SERVICE BULLETIN

NUMBER: 15-314-23

SUBJECT: Apple CarPlay & Android Auto application performance with Gen 3.1 Harman Head Unit
 -Auxiliary USB Terminal / Design Change

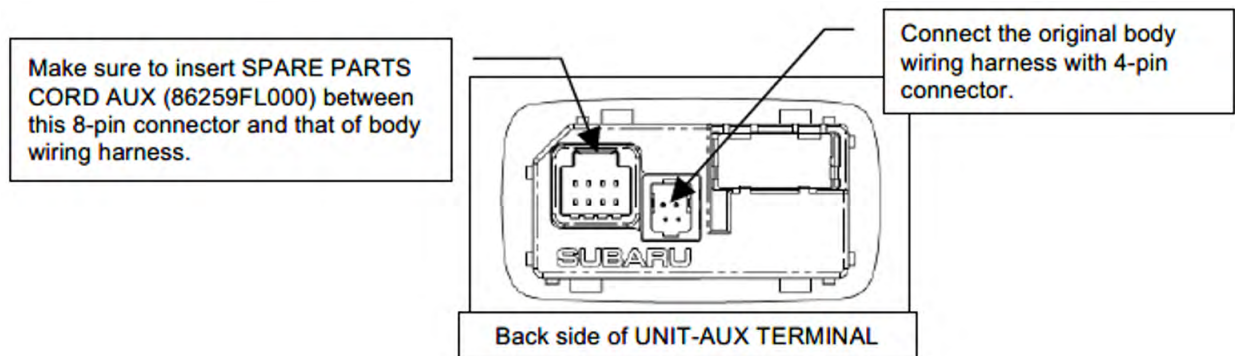
The auxiliary USB terminal and adapter cord have been modified to secure stable connection for the USB port. The Head Unit software is optimized to reestablish the connection, even if it has been interrupted for any reason. If Apple CarPlay or Android Auto connection problem is reported, update the Head Unit with the latest software version per **TSB 15-236-18R** and replace the auxiliary USB terminal with new part in conjunction with the adapter cord. The adapter cord **MUST** be replaced when a new auxiliary USB terminal is installed (Except for BRZ models).

STEP 2: Insert adapter cord (86259FL000) between the original body wiring harness (with 8-pin connector) and the new auxiliary USB terminal as the pin location on the new terminal is different from the original one. The original body wiring harness with 4-pin connector can be used without adapter cord.
